# Service Technical Information

| MODEL NO. | AM-F70 / F65                |
| SUBJECT   | "Caution!" display appears. |

REF.No. :G - 99 - 019 - E0

Fig. 1

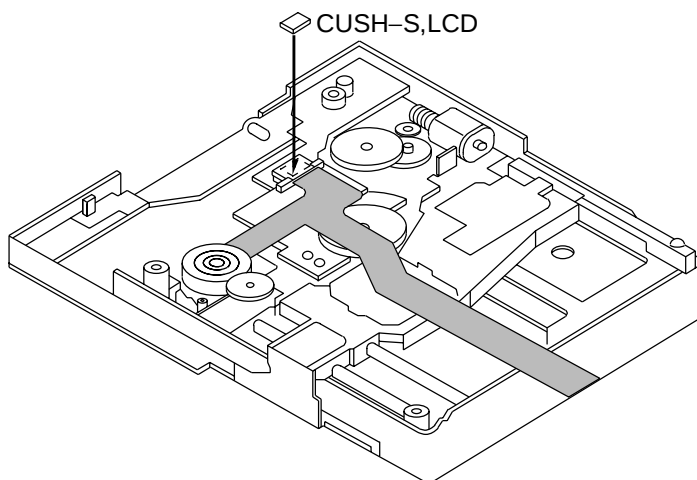
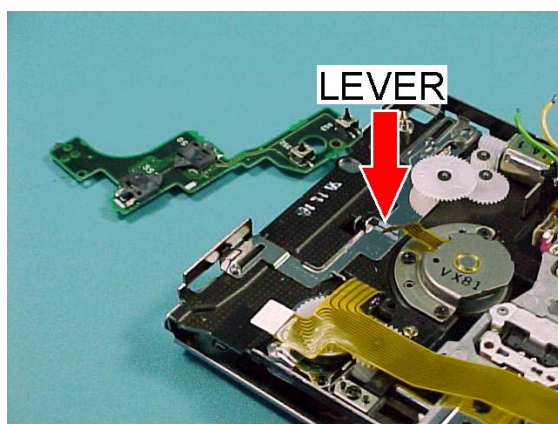
- If on/off detect of a switch fails even though the OWH position detect switch is pressed:  
Replace the detection switch with new one.
- If the lever runs on to OWH UP SW(S50) (See Fig.1):  
Remove the lever away from the switch, and then affix a cushion (CUSH-S, LCD) on to the connector of PWB, MECH (CN50).
